Re: Structural condition review and assessment  
Oyster River High School

Oyster River Cooperative School District  
**Oyster River High School**  
Structural review and assessment

Photo 7: Typical rooftop ACC installation. Note shoring under wood sleeper. Installation has no positive attachment to the roof structure.

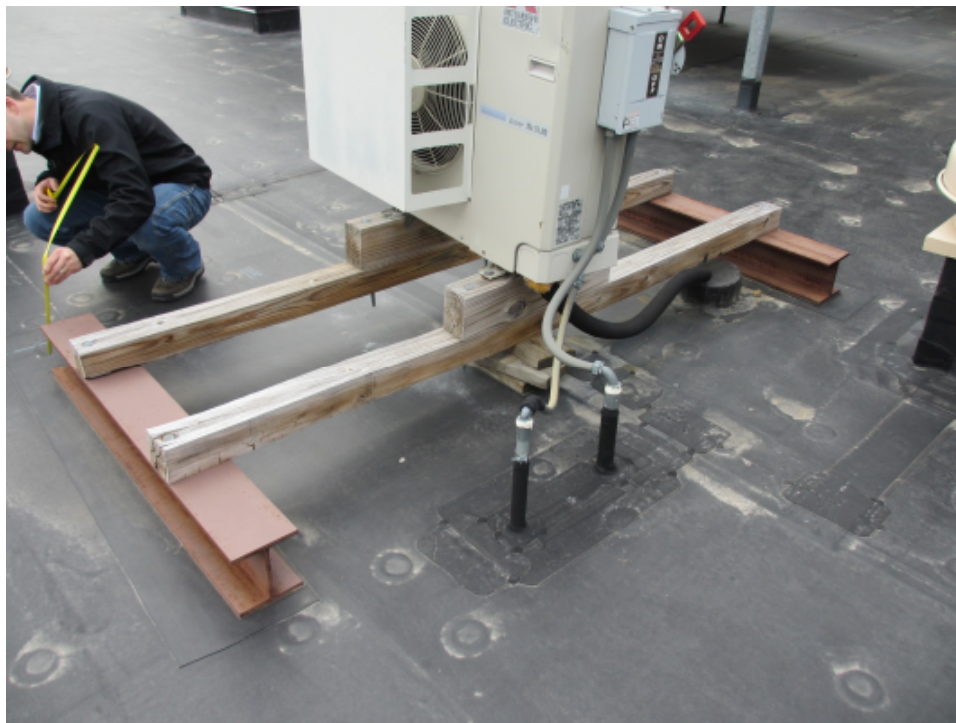
FBRA noted several instances where the 4x4 sleepers are split or sagging badly, and in one instance shims had been placed under the ACC unit because the 4x4 has essentially failed.

The entire assembly is not positively secured to the building roof and may therefore be vulnerable to wind storm damage. FBRA recommends that this support detail be reviewed by the original mechanical engineer to determine positive attachment to the roof is necessary. The support details for these units should be redesigned and modified to provide adequate support for the units.

This report has raised additional concerns with regard to the installation of the ACC and LEF rooftop units. Those installations should be reviewed by the mechanical designer to insure that these units are adequately supported and secured.

Photo 9: LEF spring isolator detail.

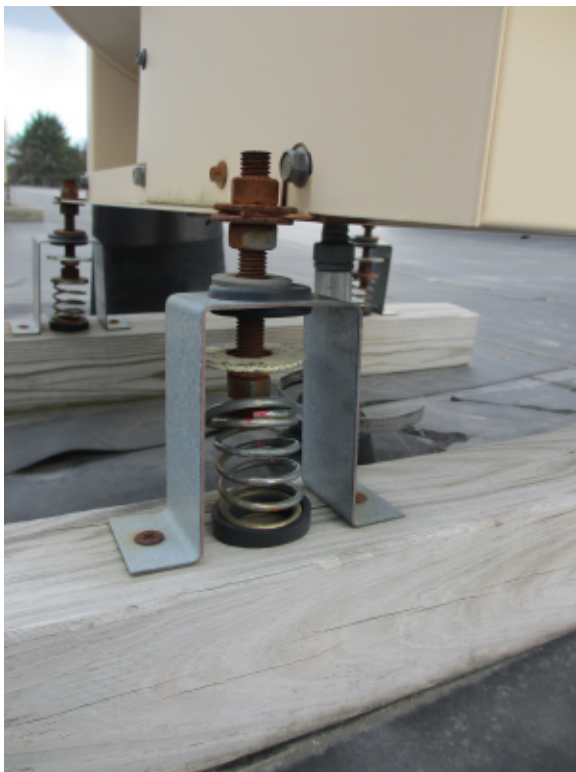
These units should be positively attached to the roof. The spring isolators that support these fan units are also irregularly installed.
